BENGALLA MINE

RESPONSE TO SUBMISSIONS

Bengalla Mining Company Pty Limited

February 2011

Figure 4: Potential Reduction in Storage Capacity

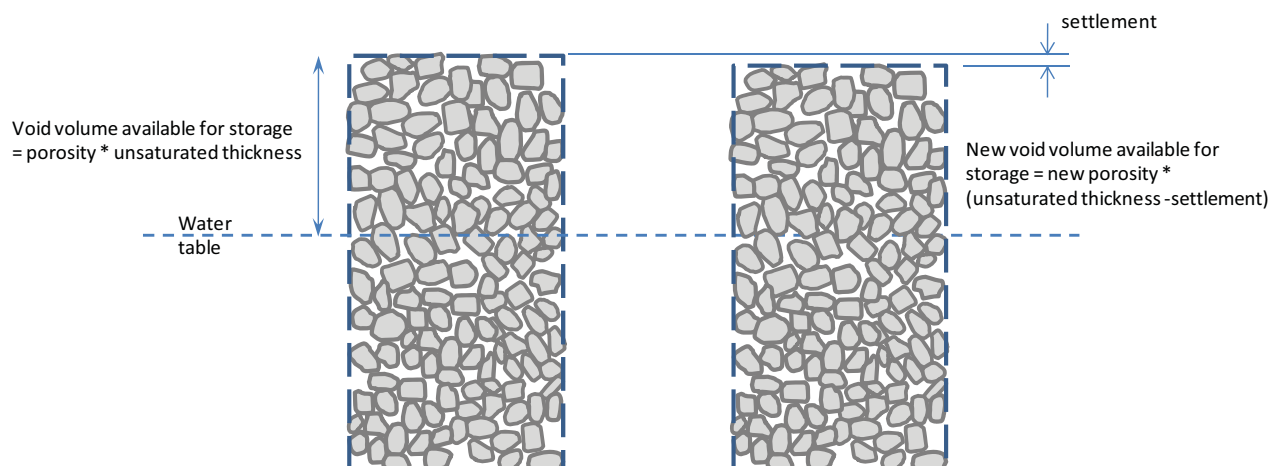
This is not addressed in the EA. NOW is not in a position to provide advice as to means to avoid alluvial compaction and consequential loss of porosity and groundwater storage in the alluvium.

Calculations were conducted based on the mine plan presented in the EA to determine the impacts on permeability of the alluvial aquifer. This assessment concluded that for the applied overburden load the resultant settlement would be 0.014 m³ per m³ of aquifer and that for an existing void ratio in the range of 0.25 to 0.35, the corresponding reduction in permeability through the aquifer would be in the order of 15 -20 %.

It is noted that the alluvial aquifers are inherently variable in their properties from place to place and the natural variability in the aquifer permeability is likely to far exceed the possible 15-20 % variation in permeability as a result of the Southern OEA Extension. Furthermore a reduced permeability of 0.8×10^{-4} m/s (a 20% reduction of the nominal figure presented in the Groundwater Impact Assessment (Appendix H of the EA) still represents a highly permeable material suitable for use as a water supply aquifer.

As illustrated by Figure 4 in Appendix C of the Golder's report, the total capacity of the area beneath the proposed emplacement to store additional water at times of high river level is governed by the thickness and porosity of unsaturated gravel above the water table, both of which will be slightly impacted by the settlement under the applied load. This is illustrated in the analysis from June 2010 which showed approximately 3-6 m of available unsaturated gravel to store additional water, 0.5 m less than maximum levels measured since 2005. The height of water level rise for a given inflow from the river may be slightly more than is currently the case due to reduced porosity, however the likely maximum reduction in porosity will be in the order of 8-10%. Thus, the change in water level for a given inflow of water will be up to 8-10% greater.
